BROWNS FERRY NUCLEAR PLANT (BFN) – UNITS 1, 2, AND 3 - TECHNICAL SPECIFICATION (TS) CHANGES TS-431 AND TS-418 – EXTENDED POWER UPRATE (EPU) – SUPPLEMENTAL RESPONSE TO ROUND 19 REQUEST FOR ADDITIONAL INFORMATION (RAI) AND RESPONSE TO ROUNDS 20 AND 21 RAI (TAC NOS. MD5262, MD5263, AND MD5264)

TENNESSEE VALLEY AUTHORITY BROWNS FERRY NUCLEAR PLANT (BFN) UNITS 1, 2, AND 3

TECHNICAL SPECIFICATIONS (TS) CHANGES TS-431 AND TS-418 EXTENDED POWER UPRATE (EPU)

SUPPLEMENTAL RESPONSE TO ROUND 19 REQUEST FOR ADDITIONAL INFORMATION (RAI) AND RESPONSES TO ROUND 20 AND ROUND 21 RAI

Figure EMCB.181-2: Dynamic Amplification

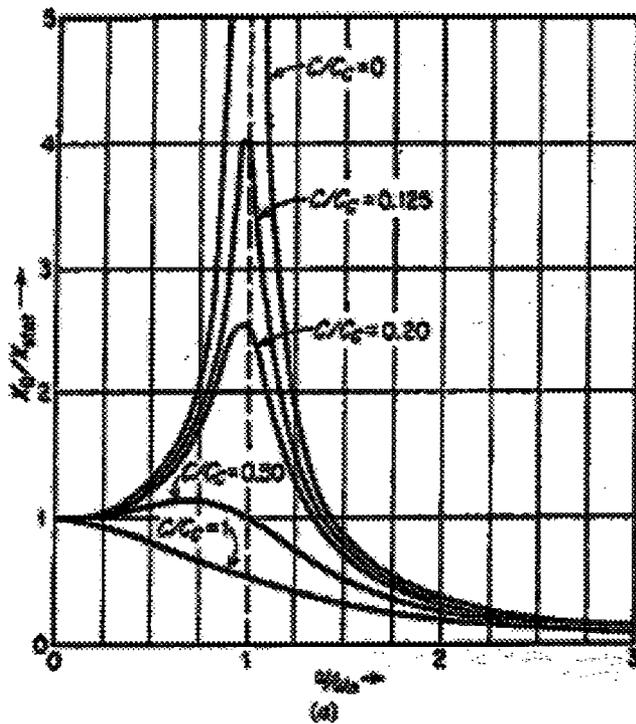
Provide further explanation of the mean filter for 0-2 Hz listed in the exclusion filtering tables.

Strain gage measurements on the MSLs are used to record dynamic/unsteady strains which are then processed to yield unsteady pressures in the MSLs. Because the steady state stresses are very large compared to the unsteady stresses, the low frequency signal shows some drift and is eliminated from the unsteady signal to be analyzed by dropping the Fourier coefficients below 2 Hz. The question as to whether this low frequency load that has been dropped is significant with regard to loading the dryer is addressed by noting that the lowest structural resonant frequency of the dryer is 6.15 Hz. Figure EMCB.181-2 taken from *Mechanical Vibration* by JP Den Hartog shows that the dynamic amplification of loads below 2 Hz with a resonant frequency of 6.15 Hz i.e., $\omega/\omega_n=0.33$ and having one percent of critical damping is negligible.

Figure EMCB.194-1a: Coherence between the upper and lower strain gage readings at BFN1 for 9% power data (MSLs A & B)

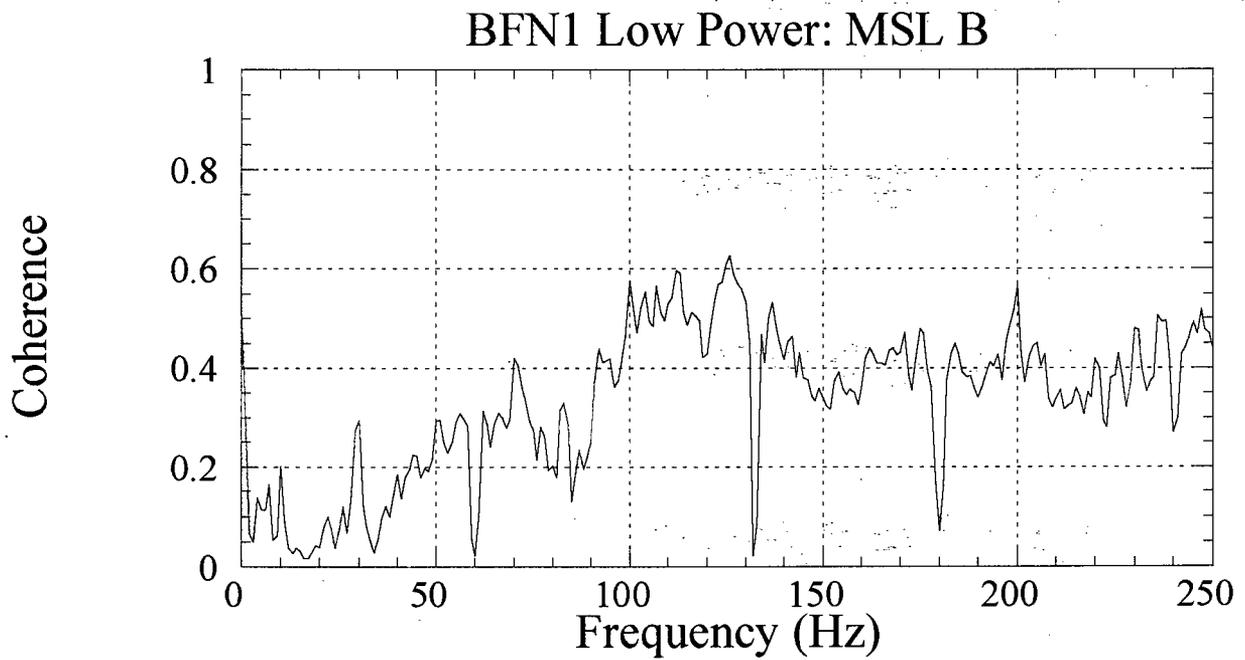
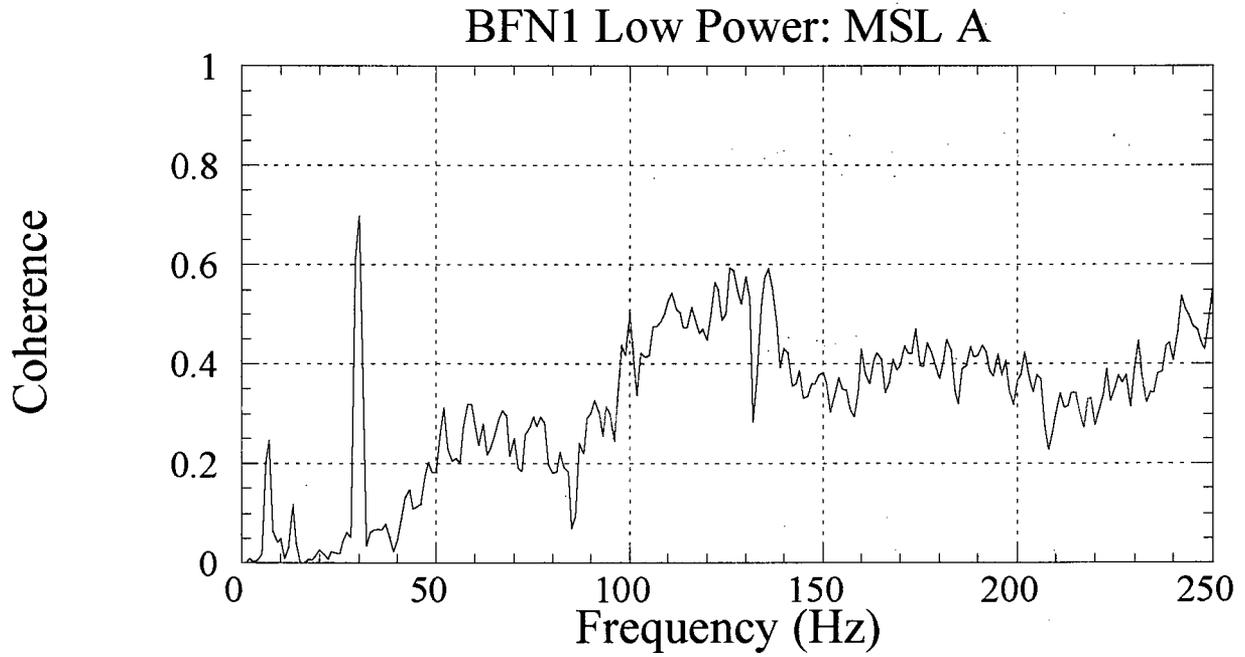
Provide the coherence between upper and lower main steam line (MSL) signals for 9-percent flow. It should be noted that only coherent background noise should be subtracted from coherent current license thermal power (CLTP) data.

Coherence plots between upper and lower MSL signals for 9% power are provided in Figures EMCB.194-1a and 1b. The 9% power signal has the LF EIC removed from it as described in the response to RAI EMCB.198 in this submittal prior to determining the coherence. Coherence filtering is performed on both the CLTP and LF signals prior to removing the noise (LF) from the CLTP signal.

Figure EMCB.195-2: Unit 1 Data MSL A Lower

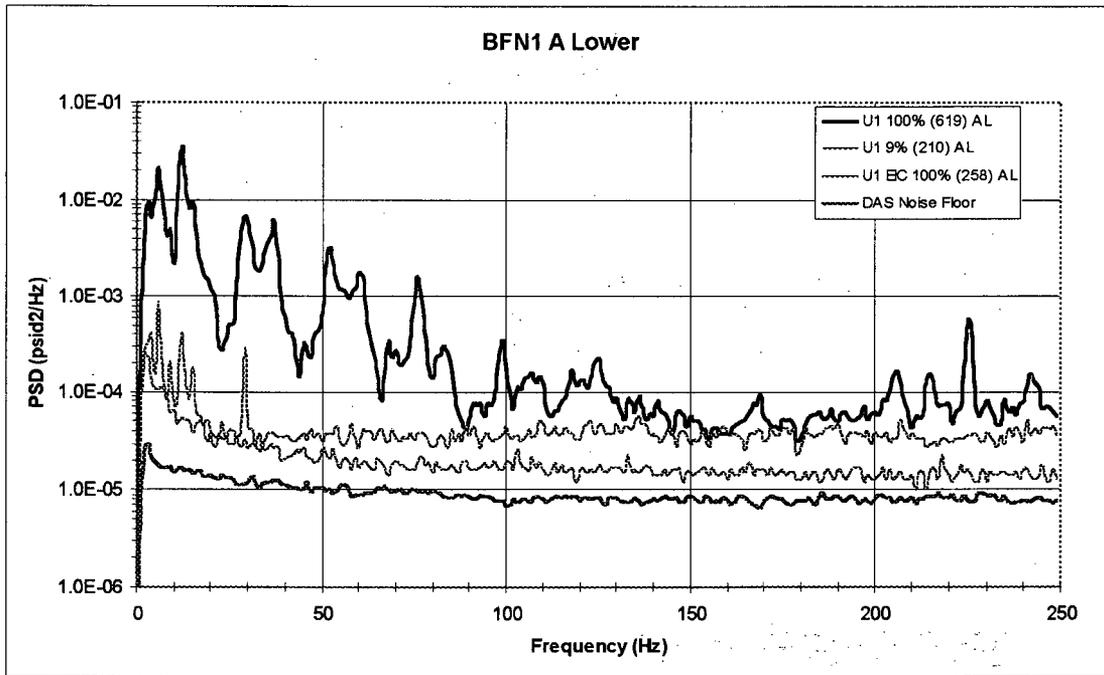
During the conference call on August 15, 2008, TVA explained that the possible reason for broad-band noise in MSL signals for 9-percent flow is up to 25 operating drywell cooling fans within containment. Provide the following fan specifications to support its explanation: sizes, flow rates, rpm, number of blades, and the proximity to the MSLs. TVA should also provide information about where peak frequencies of broadband fan noise 'mounds' (broad humps of noise) occur and, based on the fan specifications, clarify whether the fan speeds change with plant power level. If available, provide other sensor spectra within containment that show 'mounded' noise signals. Also, if available, TVA should provide the coherence between the other sensor spectra and the MSL spectra.

As can be seen in several of the Unit 1 PSD graphs provided in the response to RAI EMCB.181 in the September 2, 2008 submittal (the PSD for Unit 1 MSL A Lower is duplicated in Figure EMCB.195-2 for convenience), an amplitude peak occurs near 30 Hz which corresponds to the shaft rotation of the fans. The peak is present in the 9% signal but not in the EIC signal indicating that the source is mechanical. The most likely mode of transmission to the MSL strain gages is vibration transmitted through the steel support framing in the drywell.

Figure EMC.B.154-1: Extended Frequency Response at Varied VFD Frequency

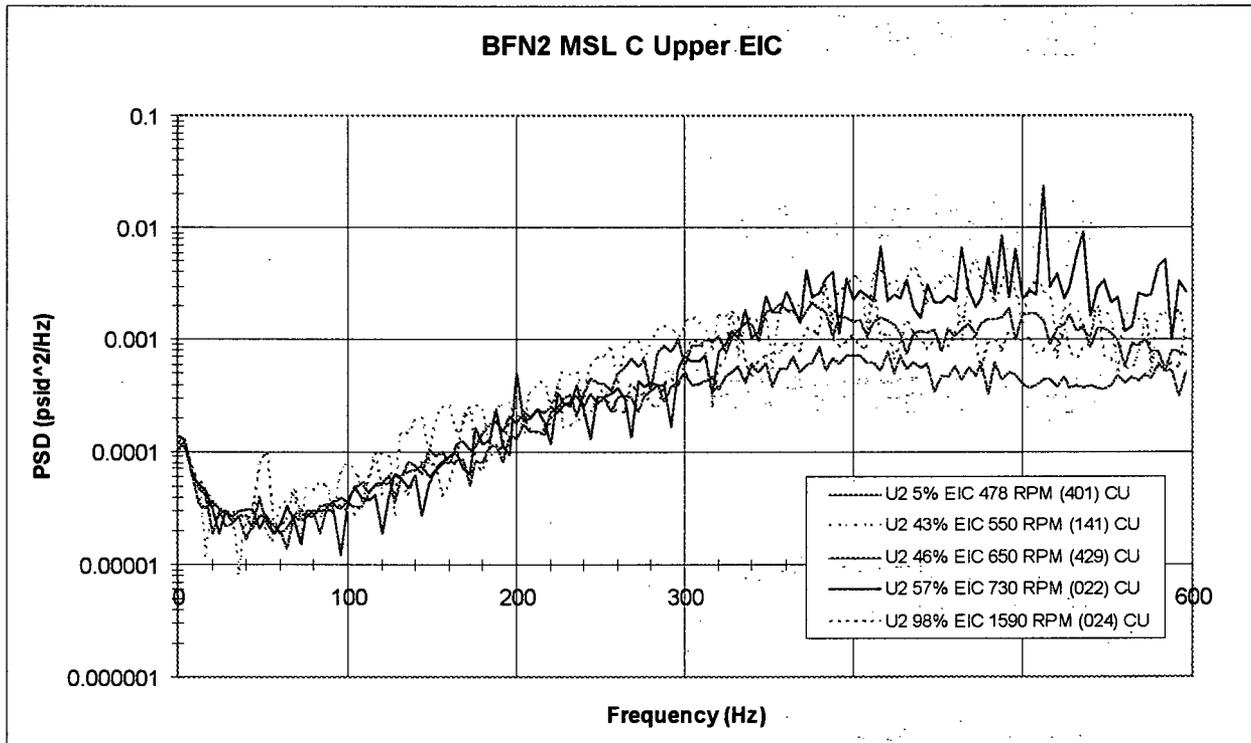
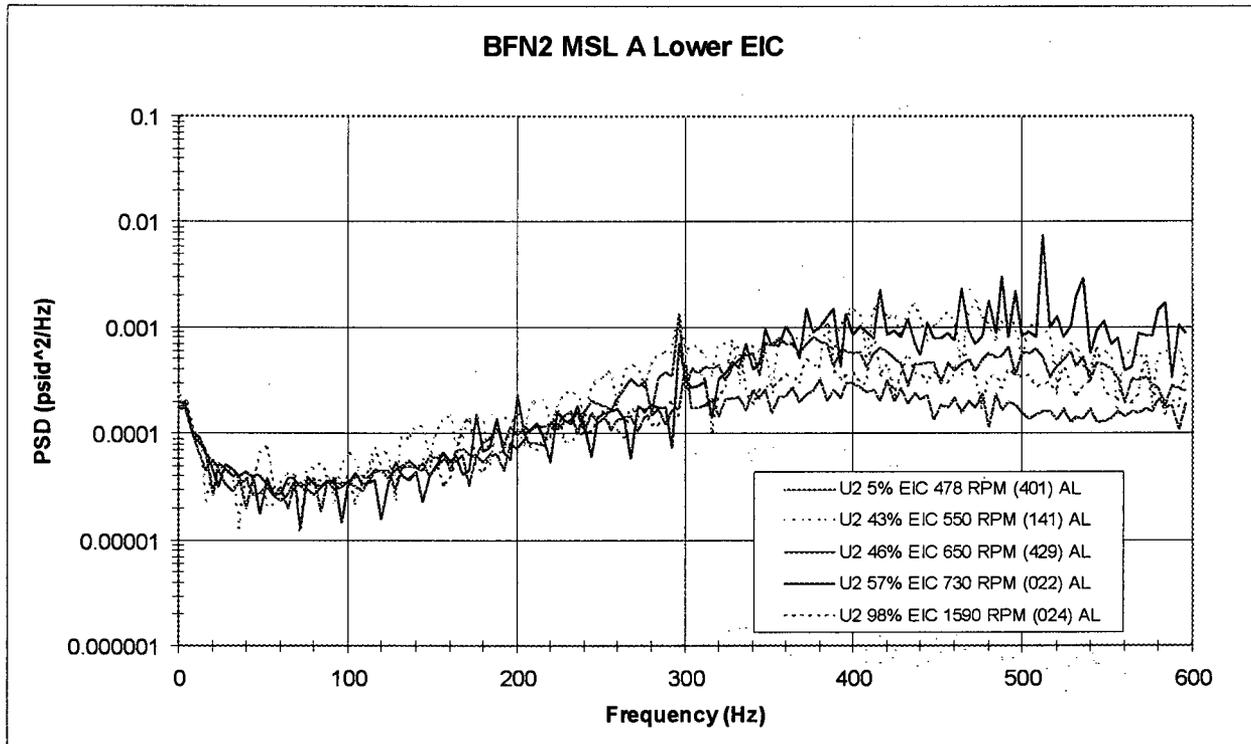
TVA indicated that the pumps are run at minimum speed at 9-percent flow. As the VFD speeds up, it is expected that the tones should move up in frequency out of the range of interest. Provide the power spectral densities up to 500 Hz (or higher) that demonstrate the tones are moving up in frequency at higher speeds. Provide the correlation with the tones observed in the strain gages based on a characteristic signal (voltage or current) in the power cables supplying the pumps.

Figures EMCB.154-1 and 2 provide EIC extended frequency plots for MSL A Lower and C Upper at varying recirculation pump speeds (designated by rpm). Recirculation pump speed of 1800 rpm corresponds to 60 Hz VFD frequency. In order to illustrate the base amplitude level, VFD frequency harmonics were filtered as they would be when developing a load definition.

Figure EMCB.198-1a: BFN1 EIC Comparison

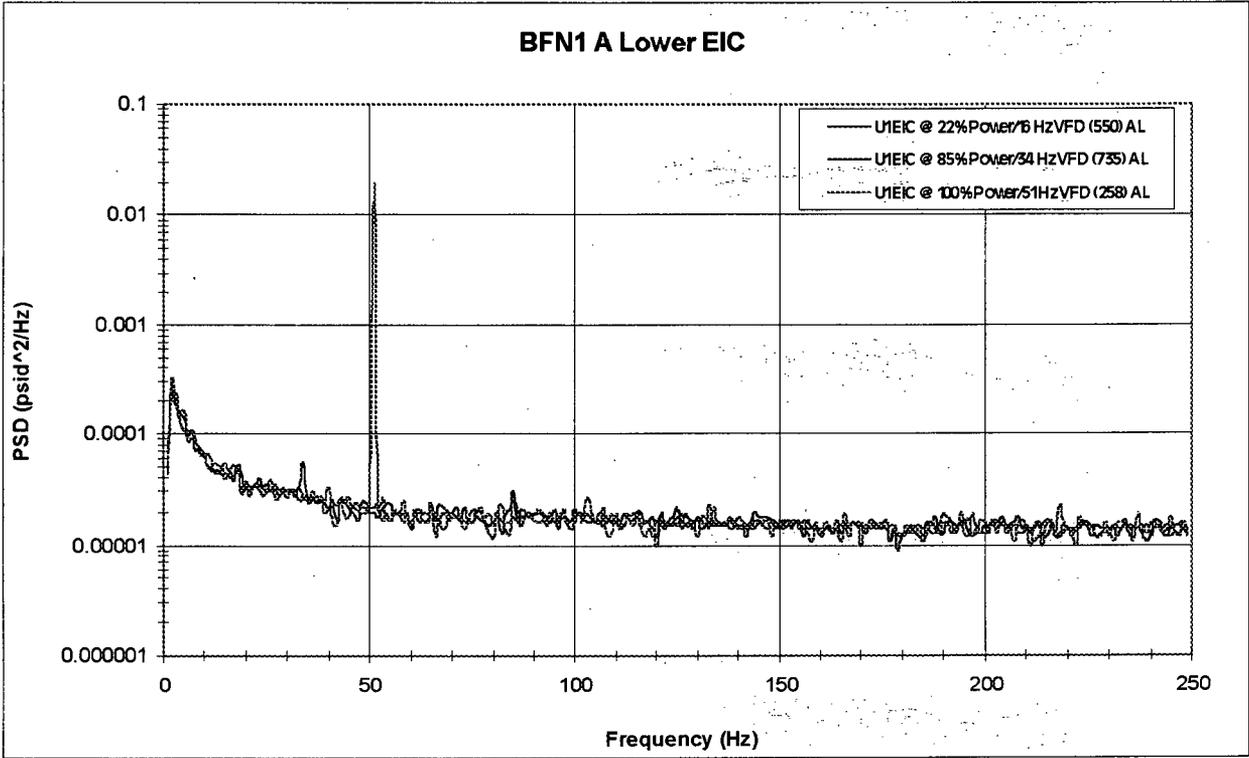
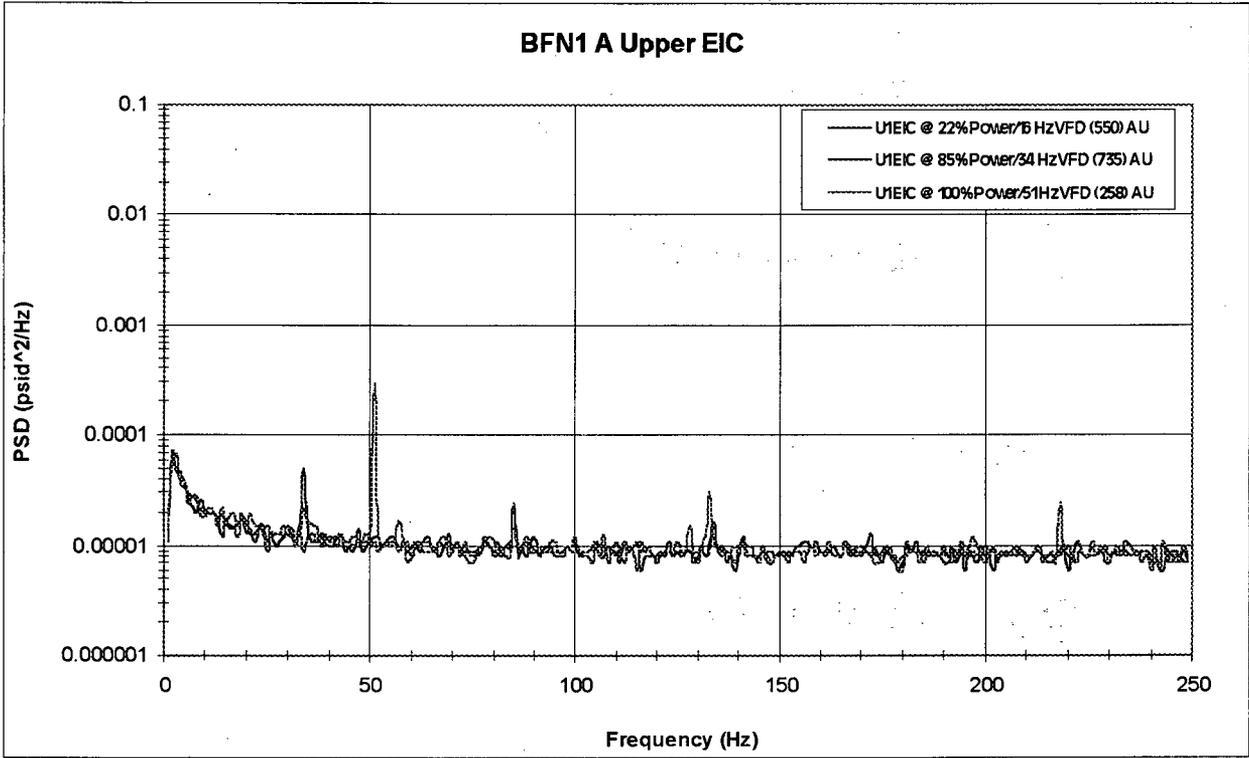
In reference to the September 2, 2008 response for Unit 1 to EMCB-181, explain whether the electrical interference check (EIC) signal at low flow conditions is the same as at the current license thermal power (CLTP) conditions. If so, provide justification, otherwise, provide a comparison of the two signals and confirm that the difference is accounted for in estimating the fluctuating pressure signal $[(\text{CLTP-EIS}) - (\text{LF-EIS})]$.

During a recent plant shutdown on Unit 1, TVA had the opportunity to collect and evaluate additional EIC signals at reduced power levels that included minimum flow conditions on the recirculation pumps. Figures EMCB.198-1a through 1d provide a comparison of three different EIC signals for each MSL strain gage array. Only mean filtering (0 - 2 Hz) and filtering of alternating current (AC) line noise at 60, 120, 180, and 240 Hz were applied in these plots; VFD frequency filtering was not performed in order to illustrate the associated VFD frequency peaks. These EIC signals consist of:

As can be seen in the comparison plots, the EIC signals at varying power and VFD operating frequencies are similar except for some peaks which are mostly associated with the operating VFD frequency and associated harmonics. Therefore, except for the matching of corresponding operating VFD frequency peaks (which are exclusion filtered after EIC removal), EIC signals taken at different power levels are equivalent and would cancel out in the operation $[(\text{CLTP-EIC}) - (\text{LF-EIC})]$. For the revised Unit 1 stress analyses, the EIC signal removed from the CLTP and LF signals will be at the same operating states.

Figure EMCB.198-1a: BFN2 EIC Comparison

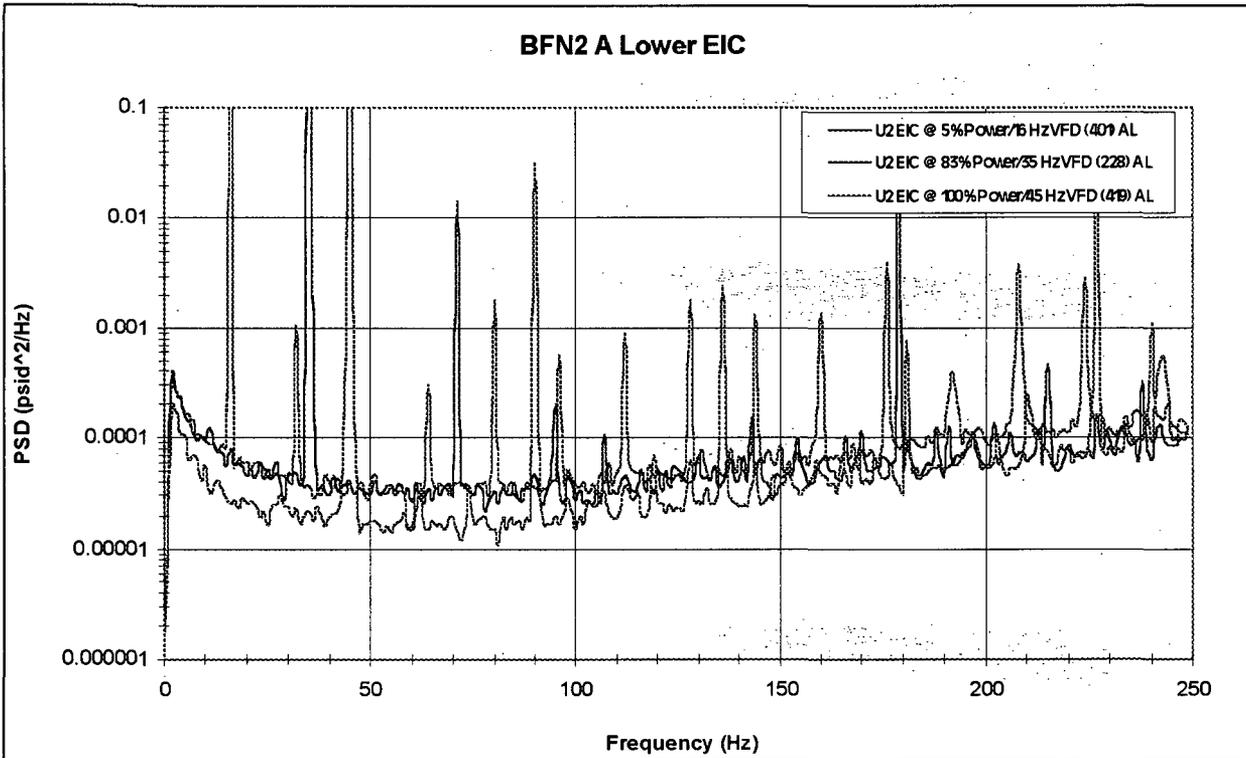
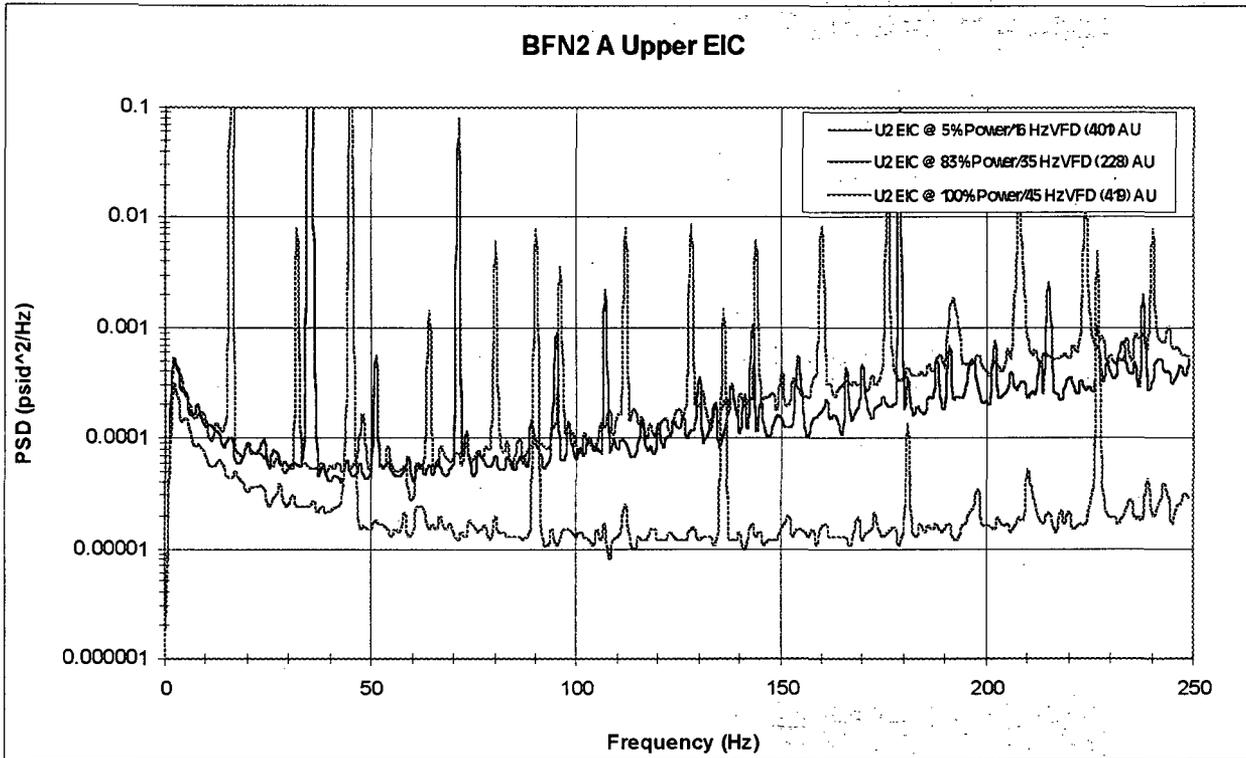
In the September 2, 2008 response for Unit 2 to EMCB-147, it appears that TVA subtracts the EIC signal from the low flow (LF) signal and treats the difference as mechanical noise (LF-EIC). Then it appears that TVA subtracts the EIC signal and the mechanical noise from the CLTP signal. The resulting signal is the acoustic pressure signal. Explain whether the EIC signal subtracted from the LF signal is the same as the one subtracted from the CLTP signal. If so, please provide justification. Note that in Figures EMCB.147-1a to 147-1d, the power spectral density (psd) for the 19 percent flow rate, in the high frequency range, is higher than that for 30 percent flow rate, which implies that the EIC noise is higher at lower pump/fan speeds.

Figures EMCB.155-1a through 1d provide comparison of three different EIC signals for each MSL strain gage array except for MSL D Lower. Strain gage failures on MSL D Lower prevent the acquisition of data for this array. Only mean filtering (0 - 2 Hz) and filtering of alternating current (AC) line noise at 60, 120, 180, and 240 Hz were applied in these plots; VFD frequency filtering was not performed in order to illustrate the associated VFD frequency peaks. These EIC signals consist of:

As can be seen in the comparison plots, the EIC signals at varying power and VFD operating frequencies vary more than the corresponding EIC signals for Unit 1 (see the response to RAI EMCB.198 in this submittal). This is likely caused by the additional noise that exists due to the close proximity of the MSL strain gage electrical penetration to the recirculation pump power cable penetration. Therefore, for Unit 2, it is necessary to obtain EIC signals at the same time that the corresponding CLTP or LF signal is obtained since EIC signals taken at different times are not the same and would not cancel out in the operation $[(CLTP-EIC)-(LF-EIC)]$.
